MV. Fella Tri Rept No 11818

also for
 MV. Cellina
 Feltre
 Rialto

1936	Data	Nome	CANTIERE MONFALCONE SEZIONE MARINA MERCANTILE UFFICIO TECNICO - GRUPPO MECCANICO Il Direttore Tecnico:	
Disegnato	14-VII-			
Controlato				
Costo. somm.				
Approvato				
Scala:	Gruppo:	Repertorio:	Costr:	
1:100				
	Motonavi "Fella" - "Cellina"			NLT 86
	Schema aspiraz. nuova intercapedine ord. 33-36			
No. Aut. 11818	Sostituito da: Sostituito da:

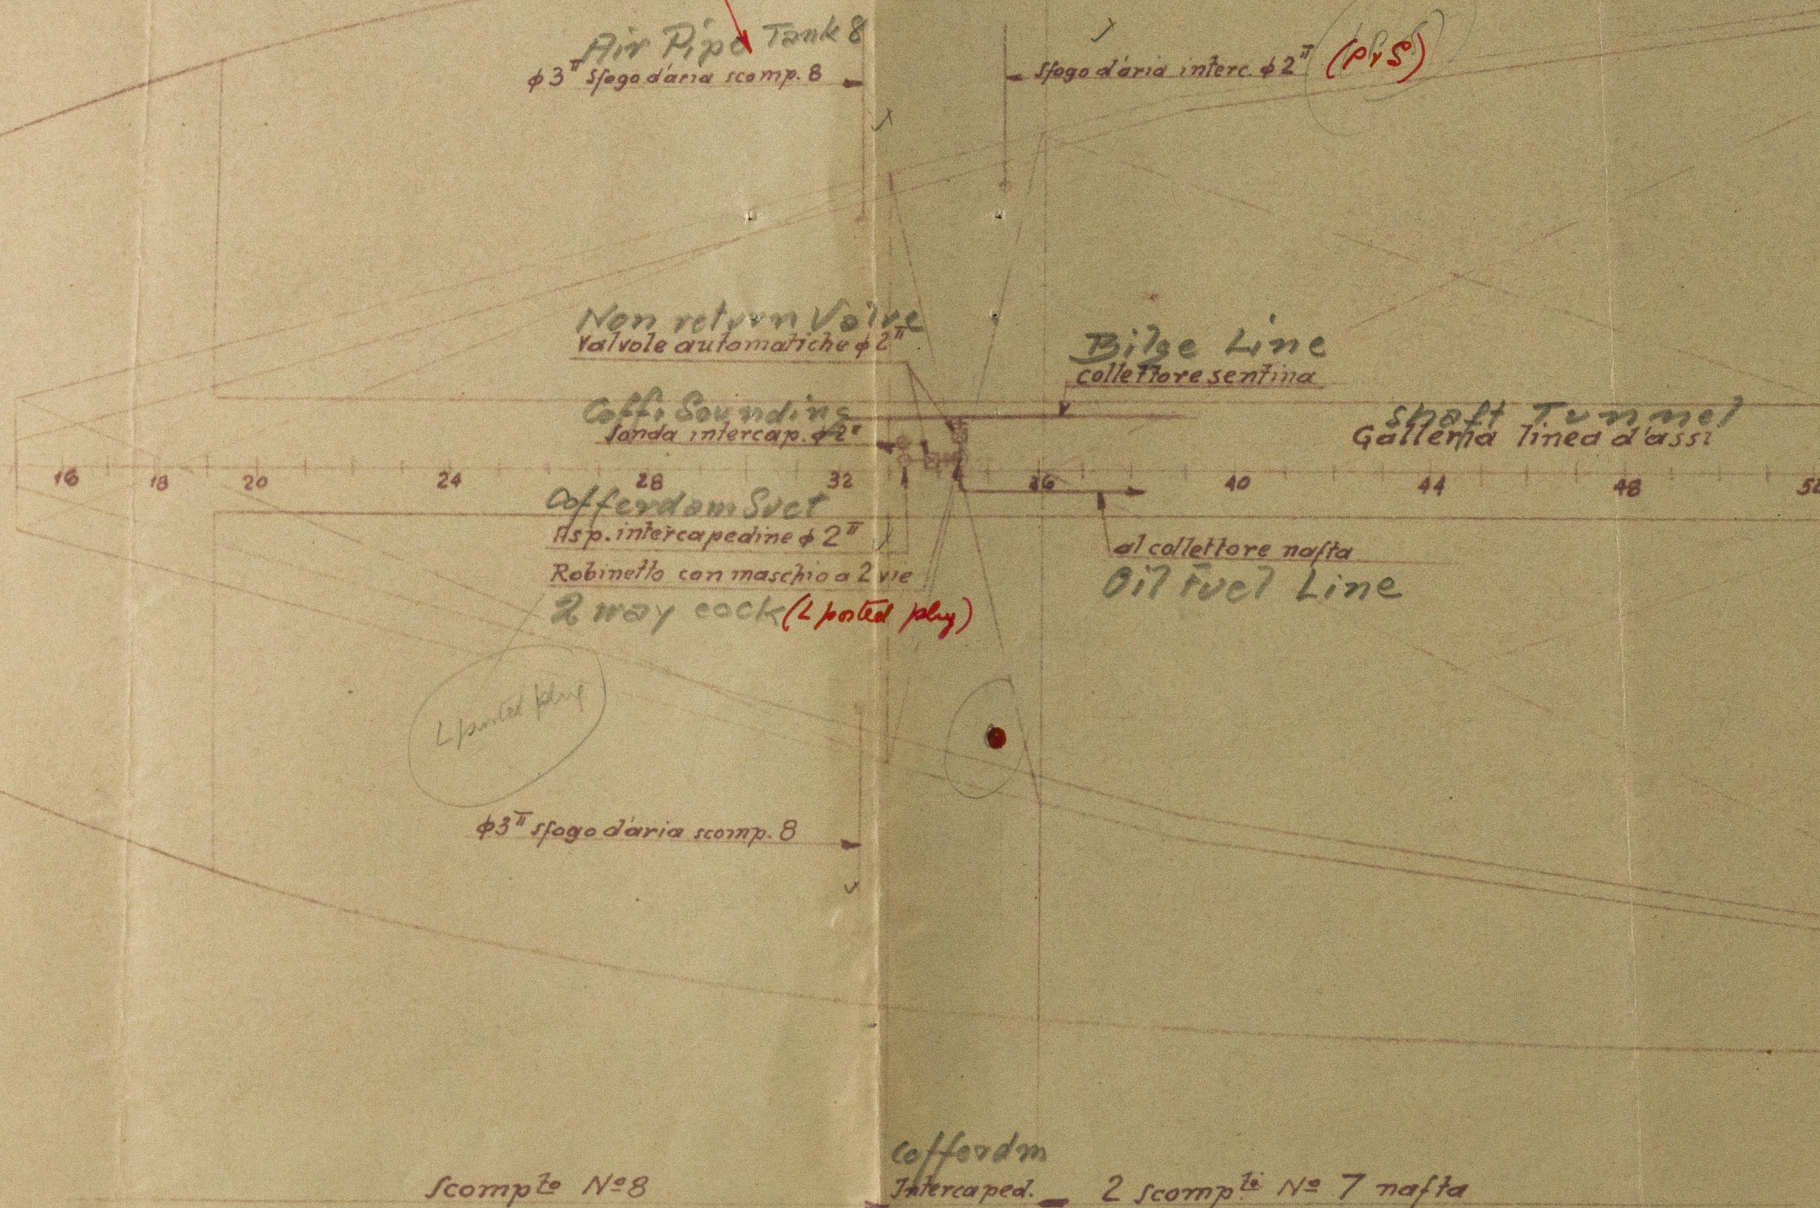
of 4" & 6" can be pumped up
 the total cross section of
 the air pipe to be not less
 than that of the respective filling pipes.
 Size of air pipe as per Rule
 as per Rule

The flash point of the oil fuel to be above 150°F. and
 the remaining requirements of Section 20 of the Rules
 1936-6 to be complied with so far as they are applicable.

The remaining requirements of section 34
 of the rules 1936-6 to be complied with so
 far as they are applicable.
